Recall Campaign Bulletin

Campaign No. 2024010011, July 2024

SUBJECT: **Various Models**
Model Year 2021-2024

Replace Fuel Pump Delivery Module – Wave 4

Figure 2

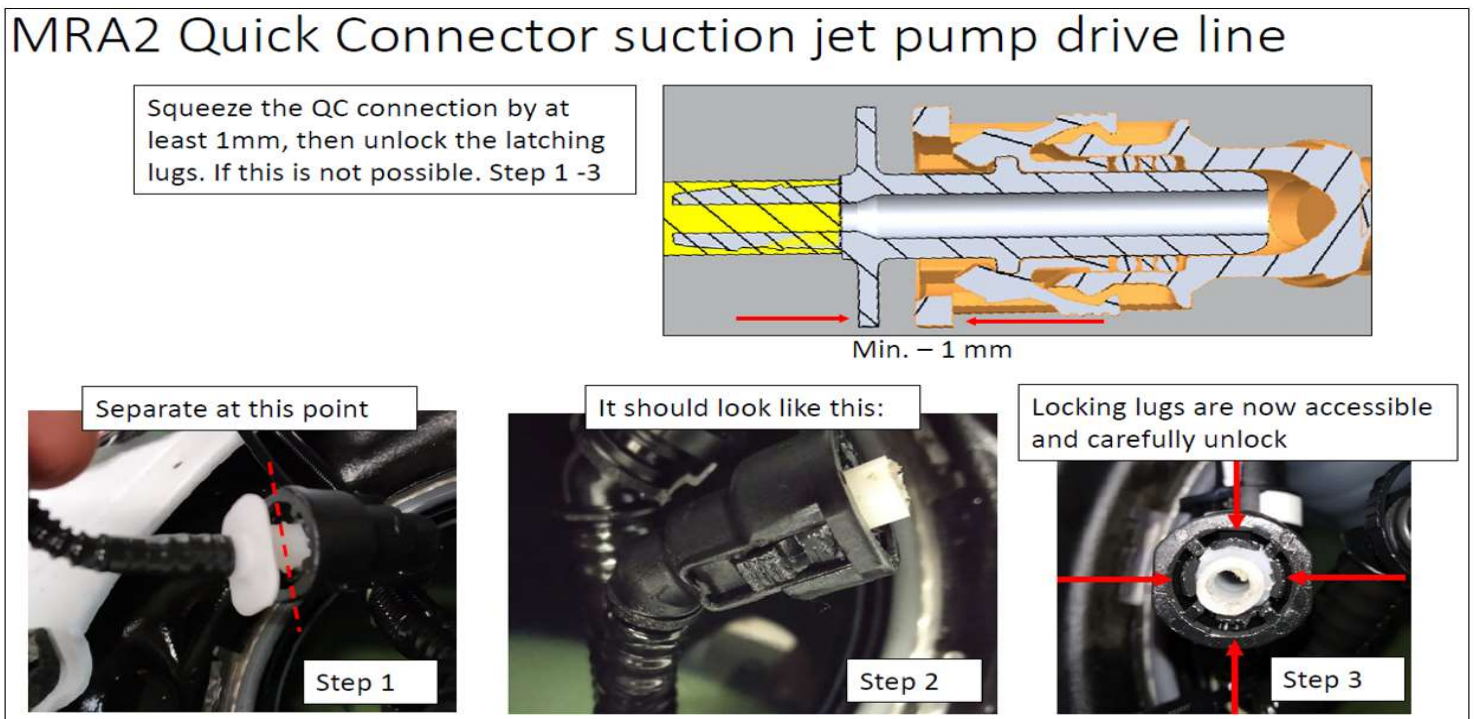
i **Only model 206, 232:** Note on disassembly of suction jet pump drive line quick connector.

The procedure steps 1-3 should only be performed when the quick disconnect is not working (**Figure 2**).

Figure 4 (remove electric lines from routing clip)

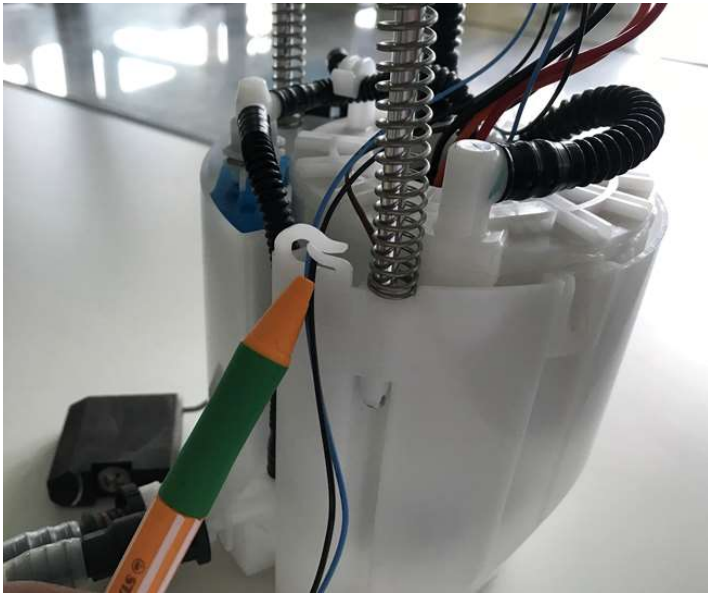
i Delivery modules that are delivered **without float-and-lever sensor** must be modified. (**Figure 4-7**)
